## Development Permit Panel

Wednesday, June 27, 2018  
3:30 p.m.

1. **DEVELOPMENT PERMIT 16-728670**  
(REDMS No. 5828465, 5877234)

PROPERTY LOCATION: 6571 No. 4 Road (formerly 6571/6573 No. 4 Road)

PLAN #1

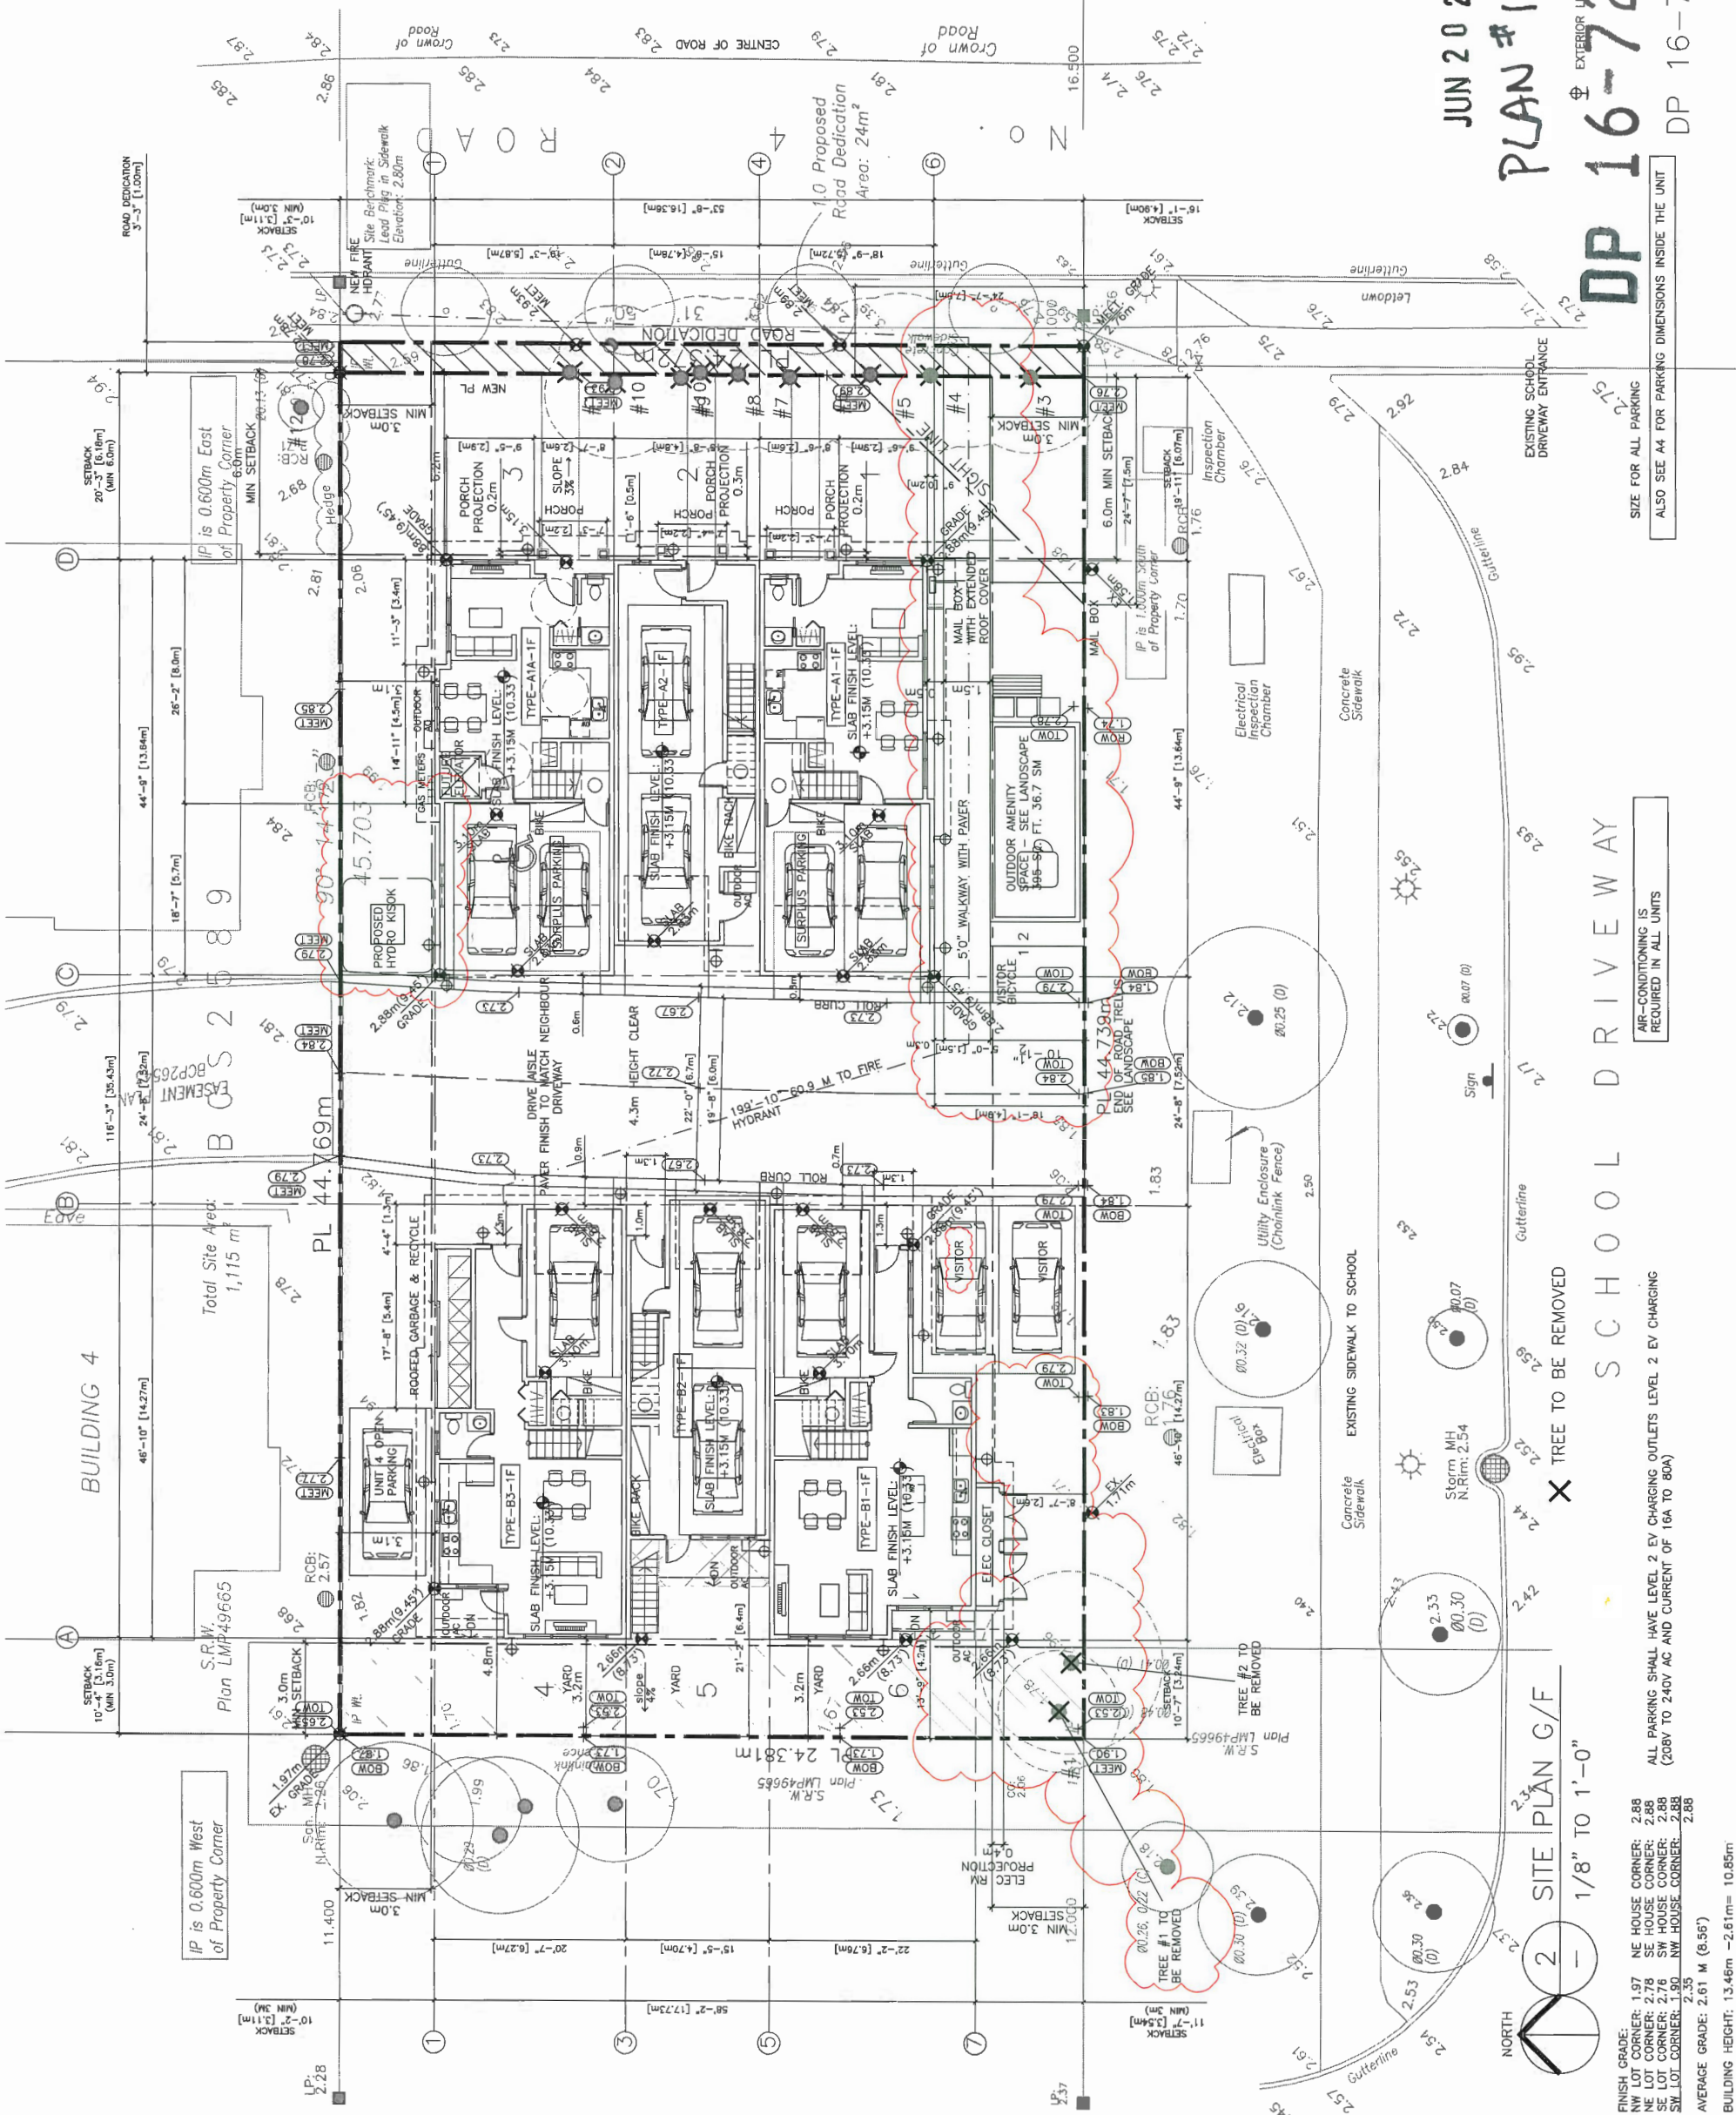
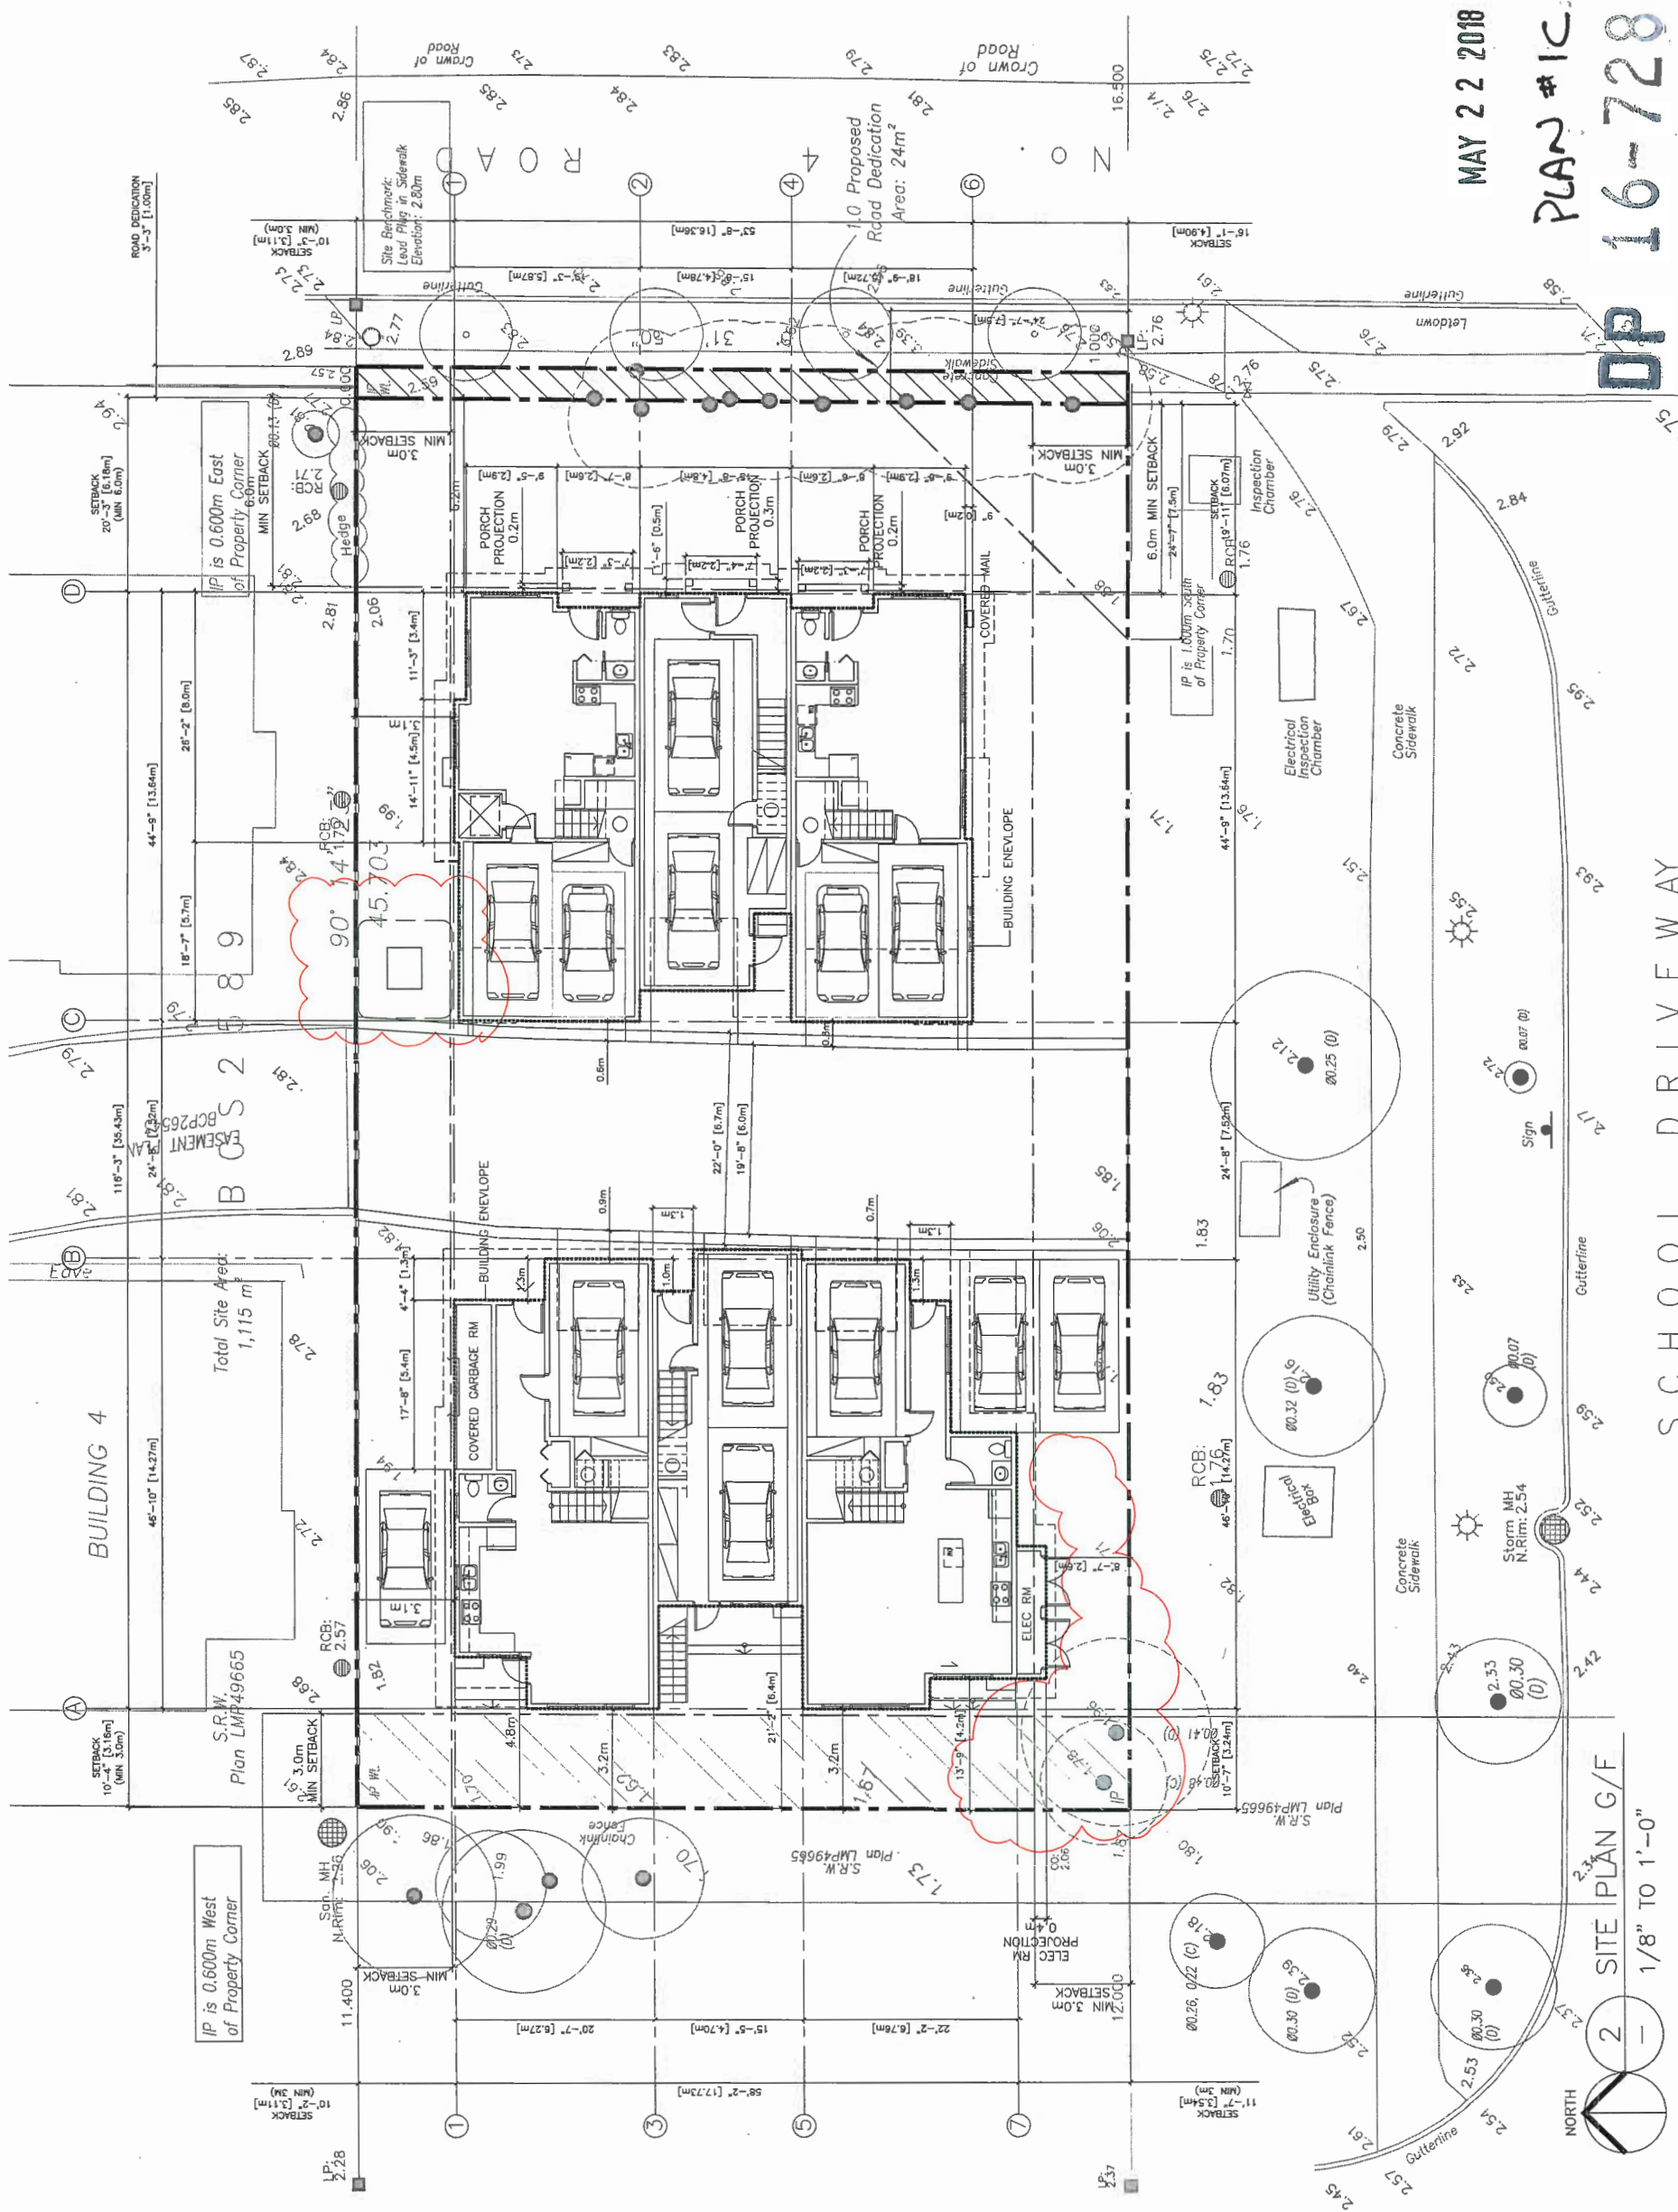
Mr. Law further noted that a significant change in the site lay-out includes the removal of one surface parking stall adjacent to the northeast corner of the internal drive aisle to allow for the relocation of the BC Hydro kiosk.

- Removal of one surface parking stall adjacent to the northwest corner of the internal drive aisle to allow the relocation of the hydro kiosk, as per BC Hydro's request. The proposed numbers of residential and visitor parking spaces are still in compliance with the bylaw. Please refer to the attached Development Application Data Sheet (Attachment C) for a comparison of the proposed development data with the relevant bylaw requirements.
